Providence City Plan Commission

AGENDA ITEM 8 ■ 269 WICKENDEN STREET

OVERVIEW

Building elevations

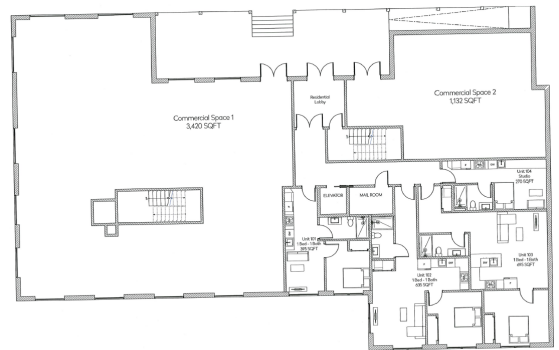
from the average grade to the roof parapet, is proposed. A dimensional adjustment has been requested for the proposed height which exceeds the 50', four story height limit of the zone.

Due to the slope of the lot on Wickenden Street, the average grade is lower than the grade adjacent to the windowsills on the first floor, resulting in a height that's over two feet from the adjacent grade. Based on plans provided, the location of the sills is influenced by the slope of the lot and location of the adjacent grade, which accommodates a portion of the cellar. It is the DPD's opinion that the CPC should grant the design waiver as the bottom of the window

sills cannot be located within two feet of the adjacent grade due to the slope of the lot.

The CPC should vote to grant the design waiver for location of sills over two feet from adjacent grade, finding that it is required due to the grade of the lot.
